CERTIFICATE OF APPROPRIATENESS

Property: 747 Arlington Street, Lot 1A, Block 258, Houston Heights Subdivision. The property includes a historic 1,568 square foot one-story wood frame single-family residence and detached garage situated on a 5,000 square foot (50' x 100') corner lot.

Proposal: Alteration – (Revision) Alter the existing fenestration pattern on the historic portion of the house

Recommendation: Partial Approval

NORTH SIDE ELEVATION-FACING 8TH STREET

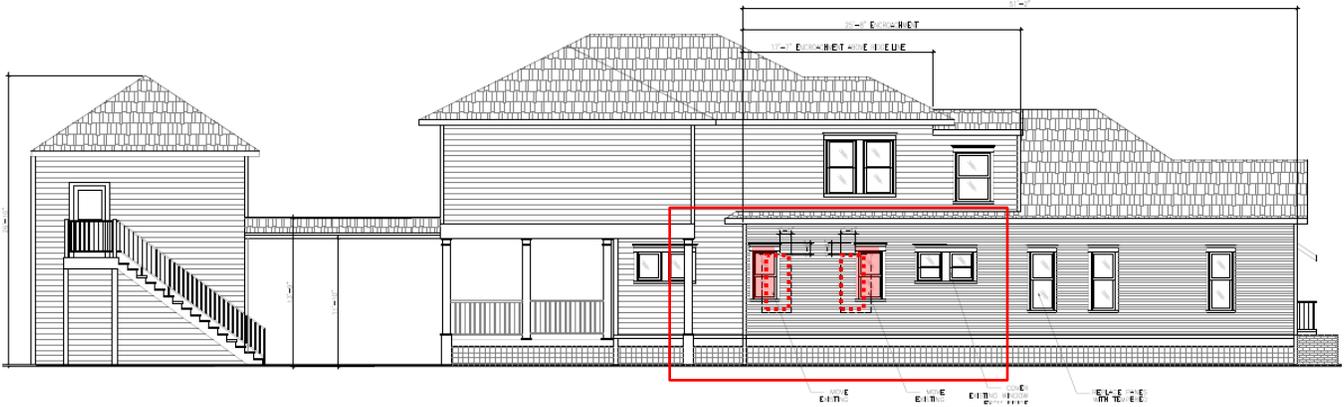
<i>The existing historic window pattern is a distinguishing characteristic of this building and should be preserved, not be altered due to interior alterations and layout changes. Additionally, the north elevation faces E 8th Street and alterations to the window patterns and siding would be clearly visible. The proposed Craftsman style door does not preserve the distinguishing character of the Queen Anne style residence.</i> |

Because Windows 26 and the proposed door at the rear of the south elevation are located on the addition, staff has no issues with them being altered. The area on the south elevation surrounding Windows 6 and 7 has previously been altered. Staff is not opposed to these windows being shifted. However, all other window alterations on the south and north elevations will lead to the loss and destruction of historic material and cause irreparable damage to the historic structure. Additionally, the proposed Craftsman style door is not an appropriate replacement because the door does not preserve the distinguishing character of the Queen Anne style residence.

I SUPPORT WITH CONDITIONS, this revised application. I support the slight raising of the existing windows as proposed and I support proposed modifications to the addition. However, I do not support the movement of existing windows on the exterior of the existing contributing structure. The visual historic character of the exterior of the contributing structure will be significantly changed from the existing condition. Changing locations of existing historic windows because it is “unusual” or “to better complement the floor plan” is not an acceptable reason to modify a contributing historic structure.

Approval of the door and fenestration changes on the addition (Windows 26) and the shifting of the two rear windows on the South Elevation (Windows 6 and 7) only. Denial for all other proposed shifting and adding of fenestration on the South and North Elevations. Denial of the proposed Craftsman style front door.

SOUTH SIDE ELEVATION

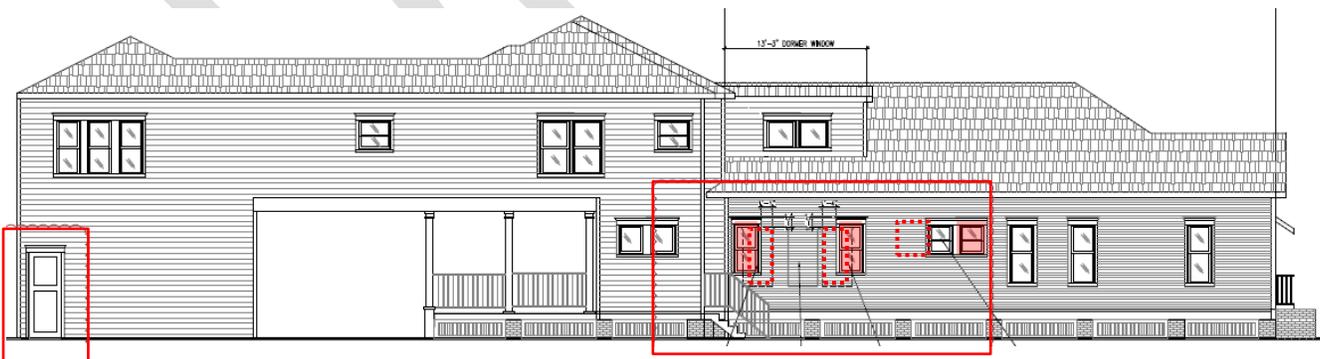
<i>Shifting windows in the original portion of the house will be extremely invasive. As this is a balloon framed house, the walls will have to be reframed and headers installed to allow for proper installation of the windows. This will not only lead to the removal of interior shiplap, but to the removal of the studs, and portions of exterior siding.</i> |

<i>Since this a balloon framed house, moving and altering several windows on the north and south elevations will necessitate additional existing wall material, shiplap, framing, and siding to be removed. The Craftsman style door does not preserve the character of the Queen Anne style residence.</i> |

DOOR DETAILS

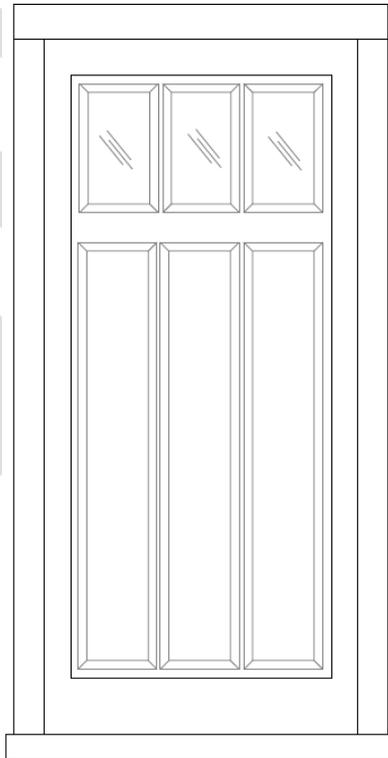
<i>The proposed Craftsman style door does not preserve the distinguishing character of the Queen Anne style residence.</i> |
